**Plan Commission Staff Report**  
**Meeting Date: September 19, 2023**

**PETITION:** PC-23-012, Rockport PUD Rezone

**REQUEST:** Petitioner requests a favorable recommendation on a rezone from Tatom PUD to the Rockport PUD, and approval of a primary plat for 129 lots. The subject property is approximately 80 acres.

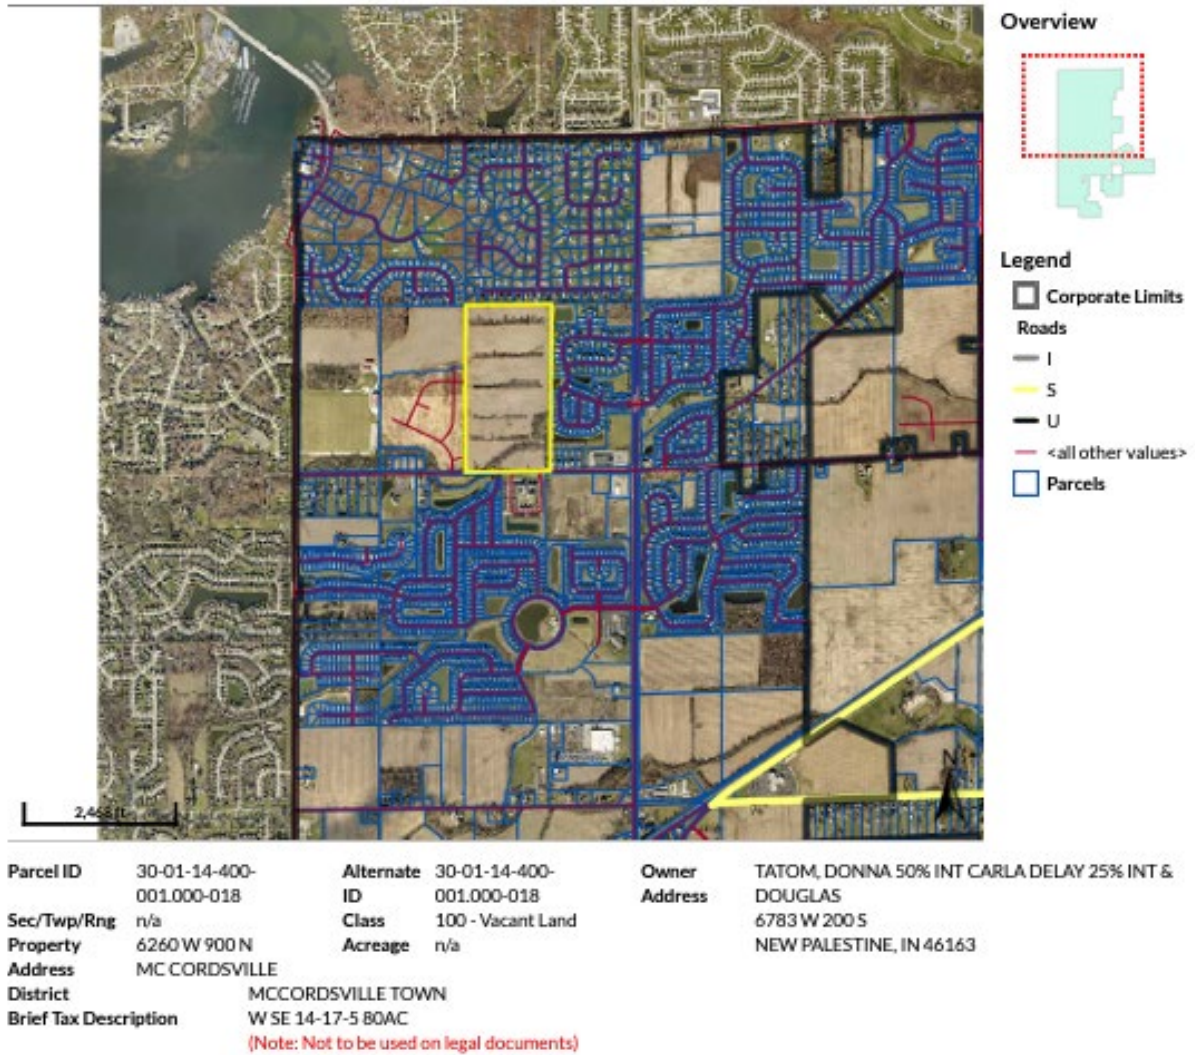
Overall, the staff is in support of this petition. While the lot sizes are smaller than the previous proposals, we feel the layout of the subdivision and large open spaces make up for the smaller lot sizes. As noted above we do have a few concerns that we would like to see addressed – the architectural elements noted above, pond fountains, and tree conservation areas. Staff cannot support the current location of Lots 76-77 and has recommended they be eliminated or relocated between Lot 90 and the legal drain.

- Approval is conditioned upon receiving zoning approval from the Town Council
- The snow removal note on the primary plat shall be corrected to read: “The HOA shall be responsible for snow removal on all internal streets”.
- The Plat is revised to include Tree Conservation Areas as determined at the Plan Commission meeting, median and street tree lawns added to the entrance drive per the PUD Ordinance, and any other changes or additions made at the meeting, shall be mirrored on the Primary Plat and re-submitted to staff.
